Service Bulletin

20-16

Model 579/567 HVAC Panel and Temperature Mode Doors Not Functioning Properly

Below is a photo of the damaged and undamaged splines.

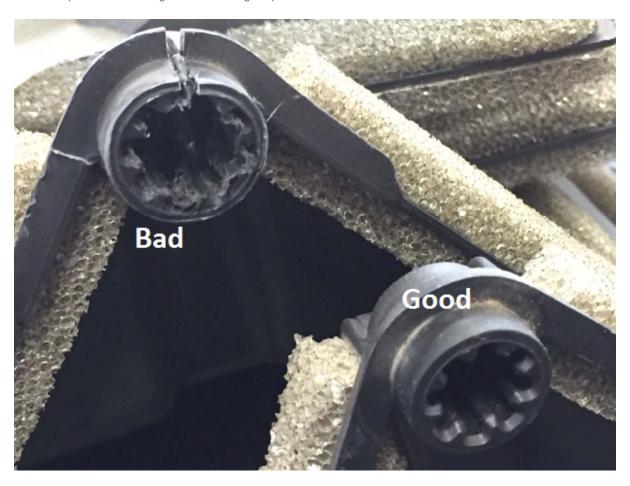
Peterbilt has determined that the HVAC panel and temperature mode doors are failing on certain Models 579/567 built between 01/20/2012 and 09/26/2016. When a temperature door fails, the operator may experience no change in temperature. When a panel door fails, HVAC air flow may not distribute properly.

Service any unit built with HVAC Modules F31-1170, F31-1243, F31-1248, F31-1250, F31-1259 that enters your dealership with either condition stated above by replacing both HVAC panel and temperature mode doors with new parts.
